Service Bulletin

SB#: SB123020-0615

Subject: Christie RF80-M Constant Potential Charge Program

Figure 1 Figure 2

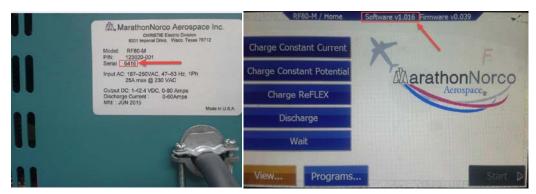
Figure 1 below shows the location of the Serial Number on the RF80-M and Figure 2 shows the location of the Software Version installed on the unit. If the RF80-M is configured with the ABMS-10X automation system (Software Version is 2.0XX) and is within this range of Serial Numbers, please contact Marvel Aero International for Software update (+1 949 829 8264).

- d. Remove Lock-out and Plug RF80-M into power outlet;
- e. Turn RF80-M power on;
- f. Software will load automatically on power up;
- g. Verify new software version (See Figure 2). If the new version is now showing on the screen, proceed to step 2k.

Figure 3

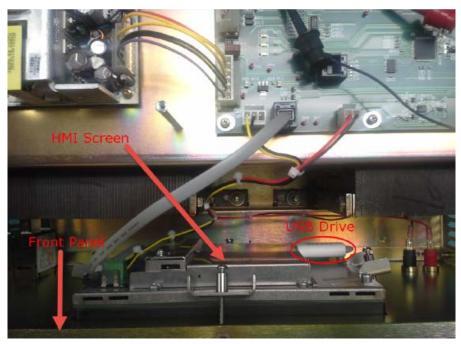
- 2. To load the new version of the software:
 - a. Unplug the RF80-M and Lock-out per your companies Lock-Out, Tag-Out procedures;
 - b. Remove the 12 screws, complete with lock washer and flat washer, on the top of the RF80-M that holds the cover in place;
 - c. Insert the USB Drive provided in step 1 above into the USB port on the right side of the HMI screen (See figure 3 below):
